REQUEST FOR TECHNICAL REVISION (TR) COVER SHEET

File No.: M- 1979-097 Site Name: East Rigden Pit

Permittee: City of Fort Collins

East Rigden Pit Mining Permit

City of Fort Collins Parks and Recreation Master Plan, 2021 (page 166) showing location of future East Community Park on land within the East Rigden Pit #M1979-79.

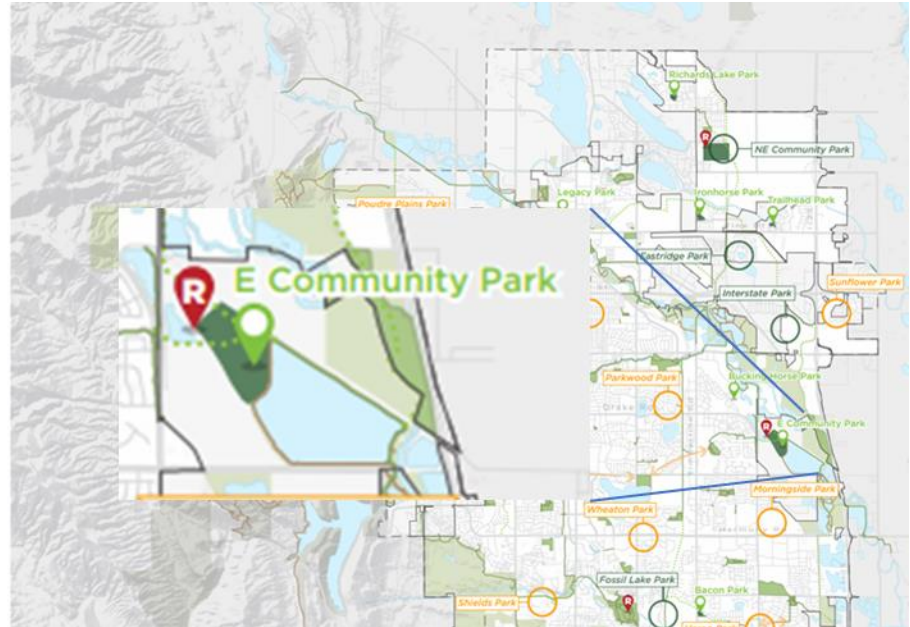
This Technical Revision seeks to remove any requirement for trees and shrubs to be planted within the permit area, in favor of two management conditions. First, 58 acres of the permit area, owned by the City is slated to become a community park, replete with a variety of native and locally adapted shade trees. Secondly, the Reservoir Parcel is currently managed as a municipal open space property with site goals focused on creating and maintaining high-quality, native habitat at all vegetation structural levels including native grasses, forbs, shrubs, and trees. Rabbitbrush has established extensively throughout the permit area (photo B is an example), and pockets of cottonwoods and peach-leaf willow (photos C and D) have established as well. In both cases, management of the City-owned mining permit area will continue to improve habitat over time with a focus on promoting the natural establishment of tree and shrub species within self-selected habitat niches.
